The Corporation of the Town of Tecumseh

To: Mayor and Members of Council
From: Phil Bartnik, Director Public Works & Environmental Services
Date to Council: June 22, 2021
Report Number: PWES- 2021-29
Subject: Riverside Drive Trail: Final Review and Recommendation

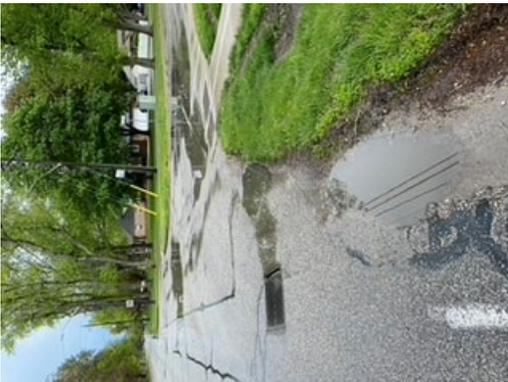
Respectfully, here is an example of 5 minutes of rain today where a trail is proposed. This is just one property.
